**TOWN OF LOS GATOS
COUNCIL AGENDA REPORT**

DATE: December 17, 2024
TO: Town Council
FROM: Chris Constantin, Town Manager
SUBJECT: Consider an Appeal of a Planning Commission Decision to Approve an Architecture and Site Application for Construction of a Single-Family Residence and Site Improvements Requiring a Grading Permit on Vacant Property Zoned R-1:8. **Located at 15411 National Avenue.** APN 424-12-140. Architecture and Site Application S-23-033. Categorically Exempt Pursuant to CEQA Guidelines Section 15303: New Construction. Property Owners: Vyankatesh and Ramya Muddada. Applicant: Jose Rama. Appellant: Hellen Martinez. Project Planner: Erin Walters.

SUBJECT: 15411 National Avenue/S-23-033

Appeal of the Planning Commission's Decision on the Proposed Structure at 15411 National Avenue

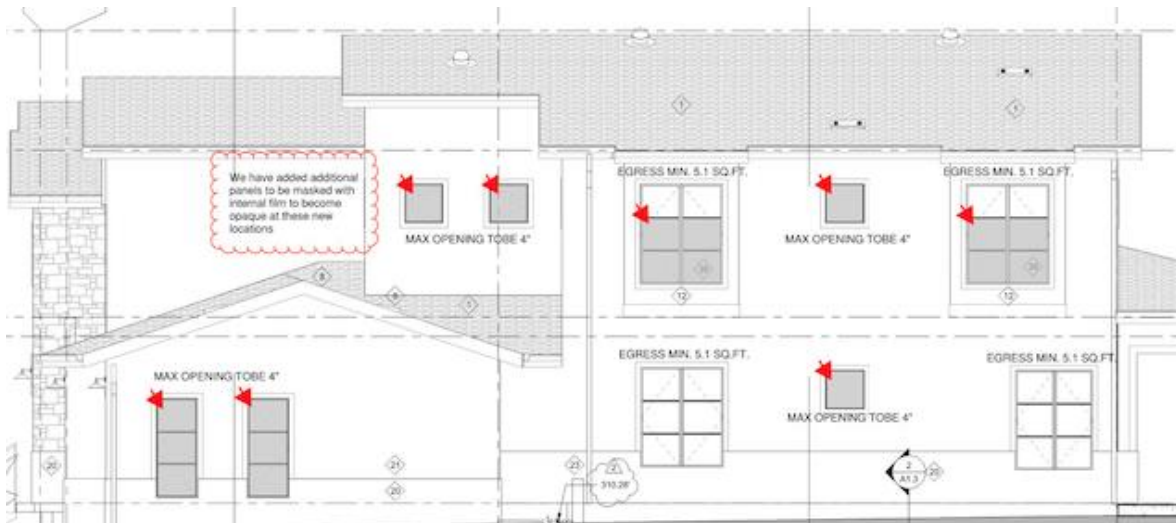
2. Due to architectural reasons, we cannot move the second egress window. There is not enough space to put an egress window due to the patio roof, and we had assured 113 Leila Ct neighbors that there wouldn't be an egress window in the back of our property (staff has this communication as part of neighborhood reach-out).

The rest of the windows are non-offensive. The windows in the bathrooms and storage are not in the line-of-sight area as they start at 8ft and end at 6ft, and the garage window is non-living space and at ground level.

Even though the garage, storage, and bathroom windows are non-offensive, we have decided to obscure them and have an opening of only 4 inches.

TOWER VISIBLE FROM THE STREET

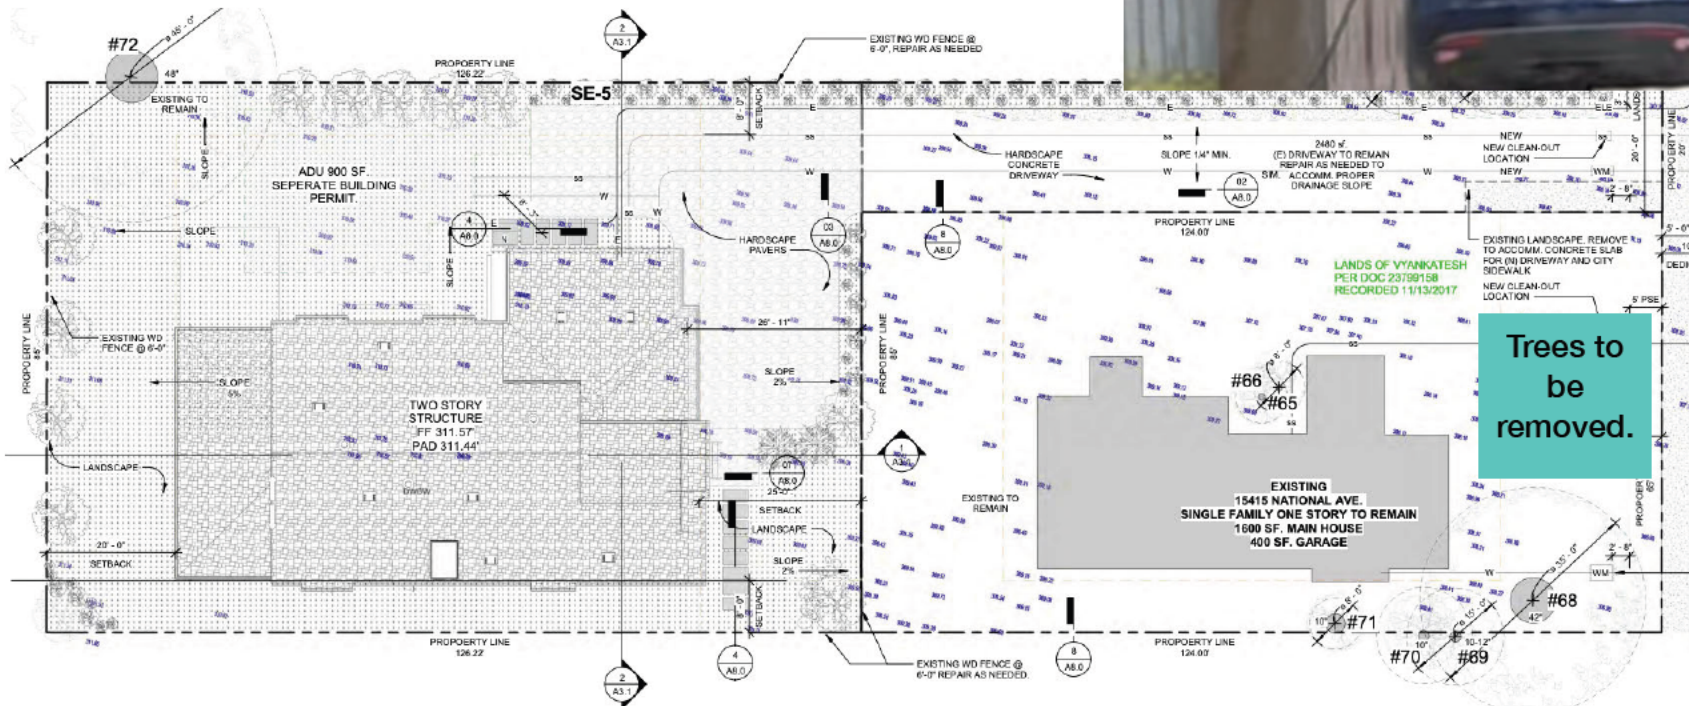
In deliberation about one of the recommendations of the Town's consulting architect not being met, and the project not meeting the Design Guidelines on this point, a Commissioner asked if the tower would be visible from the street. The answer was "no". But it seems that once the trees that are to be removed are removed, it would indeed be visible from the street.

As a side note, the house itself is visible from the street it's on (National Avenue), as well as from another street (Blackwell Dr) between the houses.

TREE (CANOPY BLOCKING TOWER) TO BE REMOVED

View of structure from master bedroom window

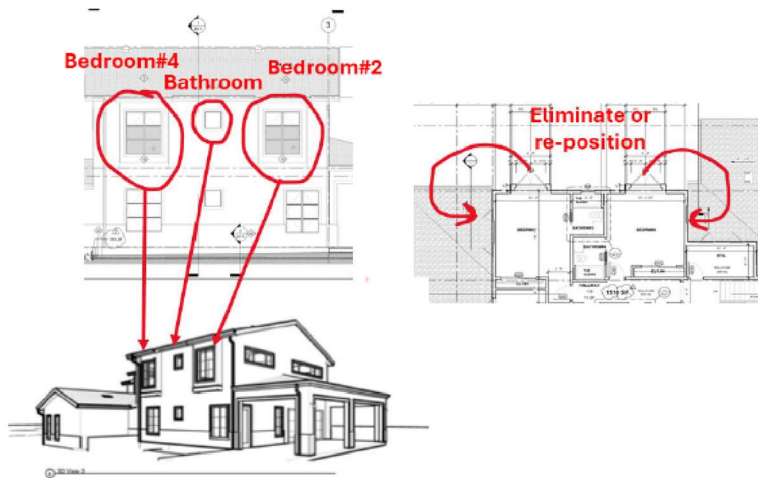
Below are a few photos of how the proposed structure would look from our master bedroom (with also a direct view into our master bathroom located behind the photographer), upstairs bedroom and downstairs bedroom. **The current proposal does not include planting any privacy trees next to our common fence** (only trees next to the common fence with 373 Blackwell Drive are planned), so **these photos truly show how unobstructed the line of sight will be.**

Significant Privacy Concerns

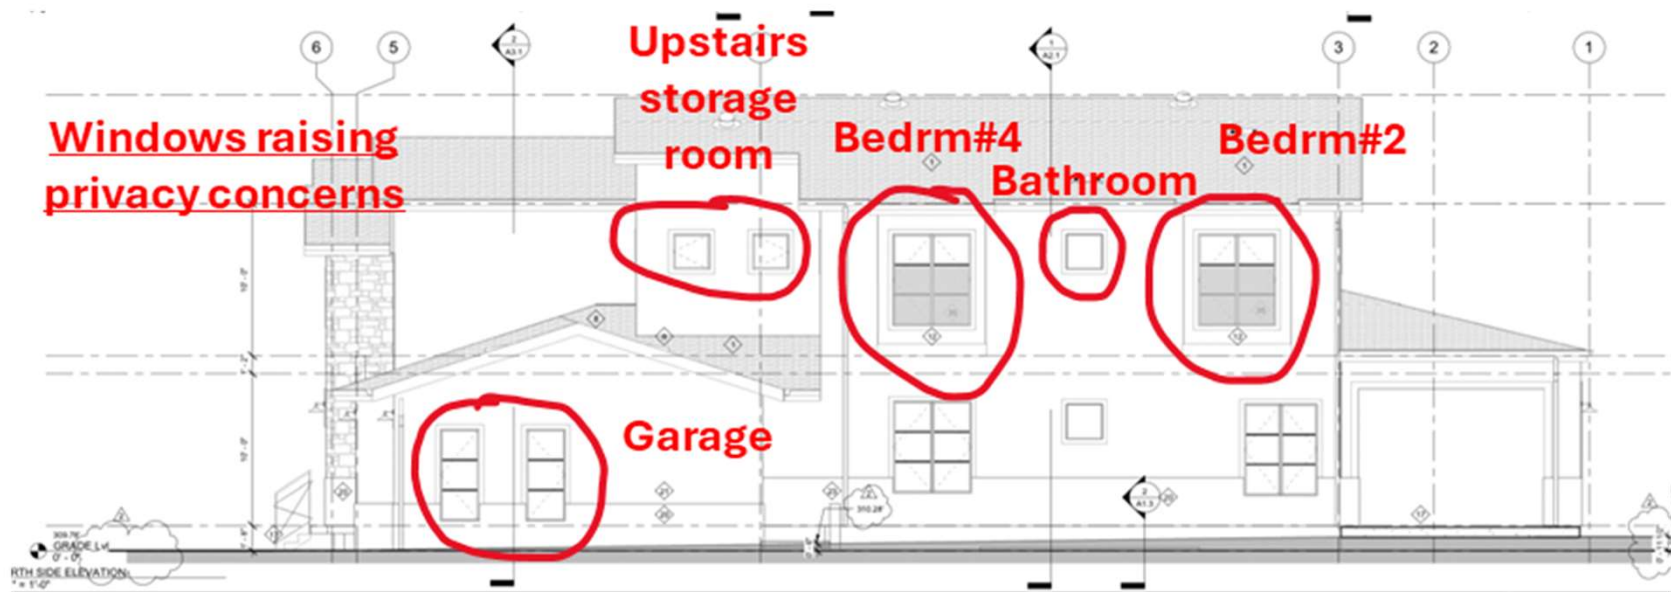
- Given its location in the center of the flag lot, the proposed structure has numerous second-floor and first-floor windows facing our property, with line of sight into our most private living spaces, bedrooms, bathroom and backyard.

Our Window Repositioning Requests

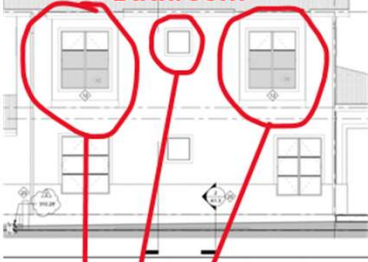
Bedroom#4
Bathroom
Bedroom#2

Garage windows

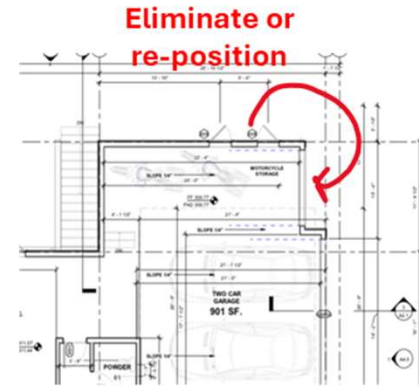
Eliminate or re-position

Upstairs
storage room
windows

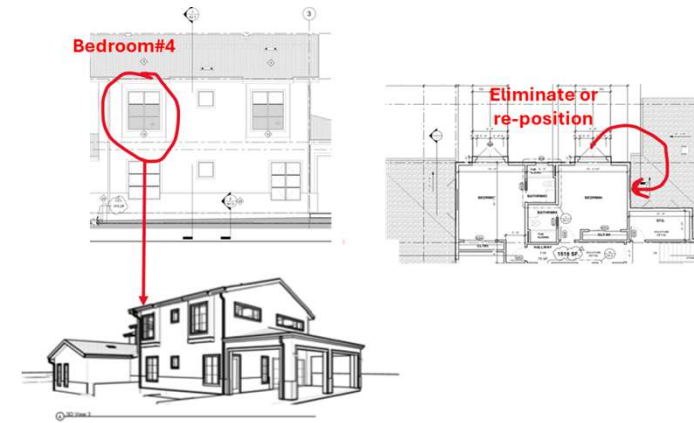
Eliminate or re-position
